IEEE Standard 62 - Comments for Revision Working Group

Pages 37, 38 and 39 - Clause 6.3.12

Figure 1

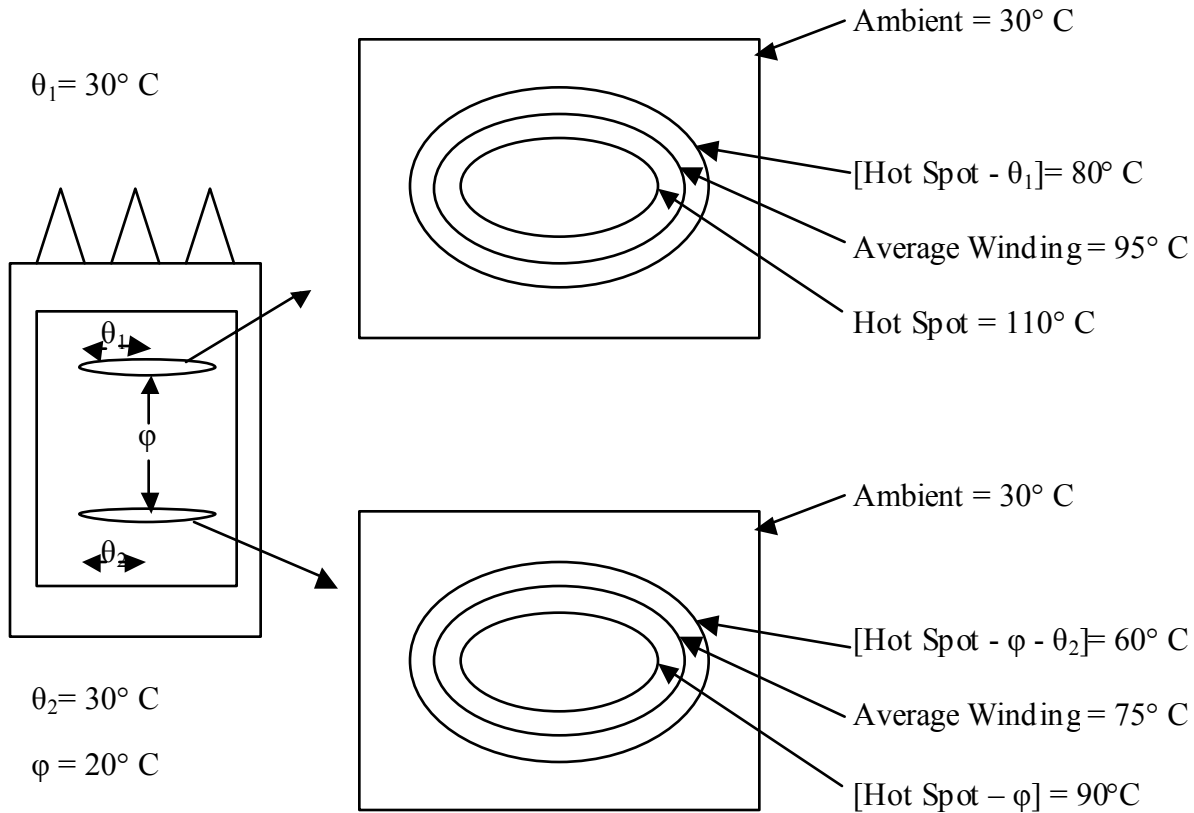
Now consider the thermograph model in Figure 1 as an example. This hypothetical model serves the purpose of showing possible temperature gradients in an operating transformer that is at constant load and constant ambient conditions (temperature and wind velocity). This model also indicates that the prediction of any single moisture in paper value is invalid. While an accurate model can only be done with temperature probes, nonetheless it is clear here that moisture curves predict a range of moisture values whenever there are temperature gradients. Next, adding the conditions of changing load and ambient conditions further complicates any quantitative analysis. Finally, since the percent saturation is also dynamic parameter then serious errors result as well when placing equilibrium values in a graph or table. This revision should remove the clause or revise it to conform to IEEE PC57.106/D6 which has been submitted to RevCom for approval.

$\phi = (\text{Hot Spot Temp.}) - (\text{Maximum Temp. in Horizontal Plane at bottom of Coil})$

$\theta_1 = 2 \cdot [(\text{Hot Spot Temp.}) - (\text{Avg. Winding Temp at Top Coil})]$

$\theta_2 = 2 \cdot [(\text{Hot Spot Temp.}) - (\phi)] - (\text{Avg. Winding Temp at Top Coil})$
